**SUBJECT: Duke Power Company LLC d/b/a Duke Energy Carolinas, LLC  
(Duke)  
Oconee Nuclear Station, Units 1, 2, & 3  
Docket Numbers 50-269, -270, -287  
Relief Request 06-ON-004 Request for Additional Information**

OCONEE NUCLEAR STATION  
RESPONSE TO  
REQUEST FOR ADDITIONAL INFORMATION  
REQUEST FOR RELIEF No. 06-ON-004  
Pressurizer Alloy 600 Weld Overlays  
(TAC Nos. MD2887,2888,2889)

Figure 1 Residual Stress Distribution from White Paper (see Text)

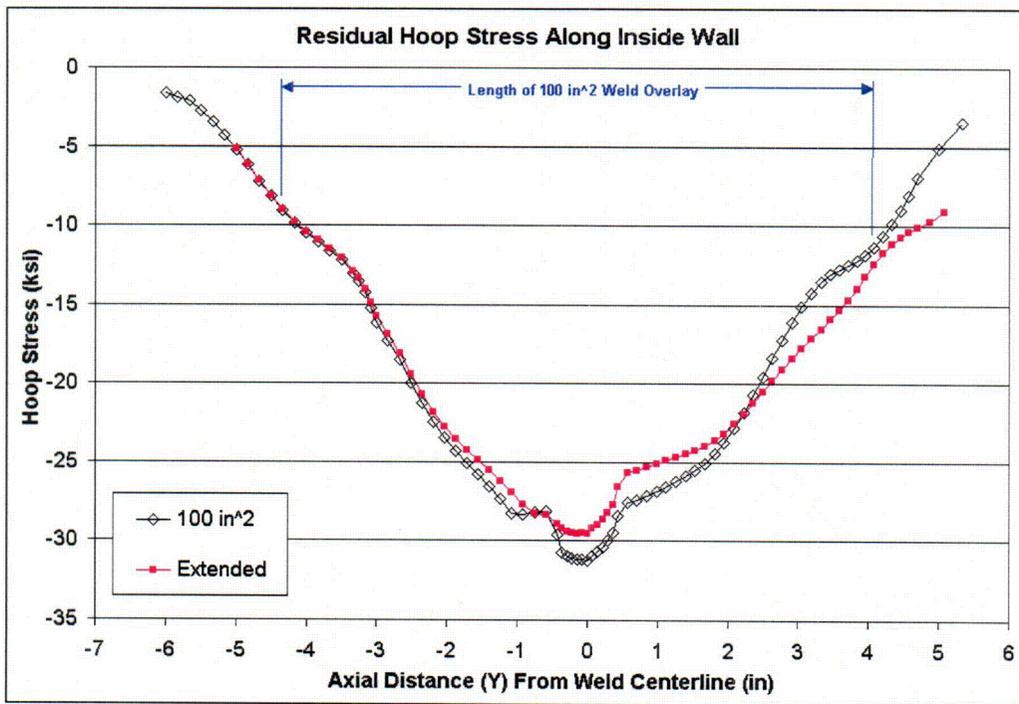
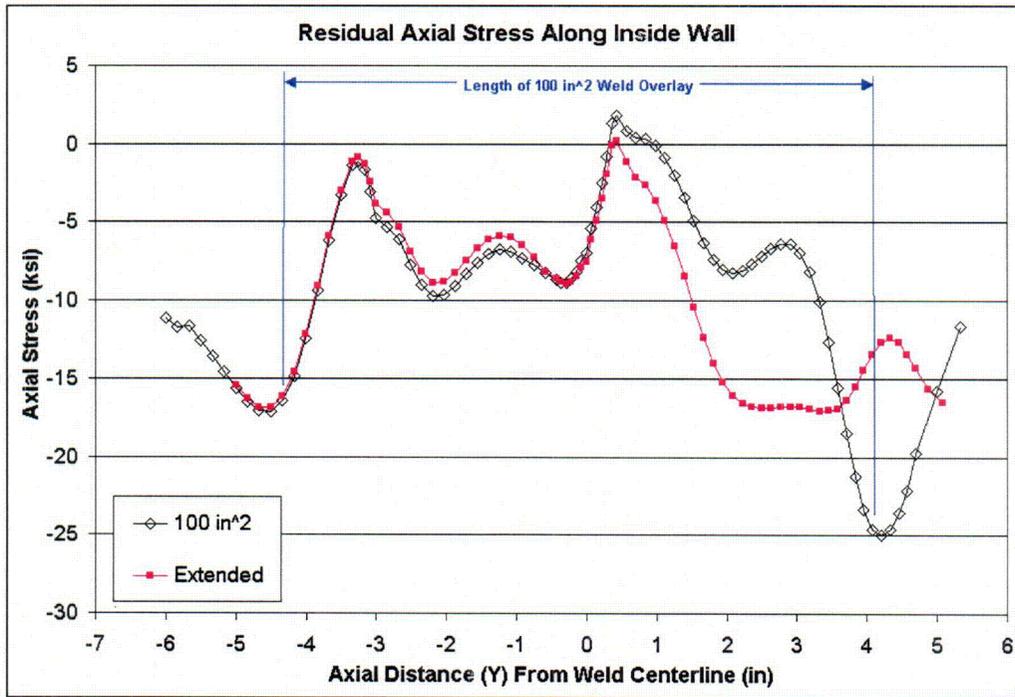
4. On page 5 of your submittal, you indicate that Code Case N-638-3 was recently approved by ASME, increasing the limit for temper bead welding over ferritic material. In your Table 3 list of alternatives you cite N-638-3 and the associated white paper as the basis for your alternative to exceed 100 sq.in. The staff has not approved this Code Case in Reg. Guide 1.147, Rev 14., and as such, the staff may take considerable time to evaluate your alternative. Another approach may be to provide a basis that is consistent with other alternatives that the staff has approved. Part of your discussion should include similarities between your plant and those listed in your precedents section of the submittal and why the resultant overlay will not prevent the component from performing its design function.

(a) Residual Stresses – Using as an example a BWR Feedwater Nozzle, the white paper cites EPRI sponsored analyses [1] of an overlay that just equaled 100 in<sup>2</sup> coverage over the ferritic steel base metal. Two axisymmetric finite element models were created, one with the 100 in<sup>2</sup> weld overlay and the other with the weld overlay extended on the nozzle side until it blended into the nozzle taper surface (approximately 126 in<sup>2</sup>). Figure 1 shows the post overlay residual stress on the nozzle inside surface for both models. It is seen that the extended overlay configuration did not significantly alter the residual stress results, and if anything, made the axial stresses even more compressive.
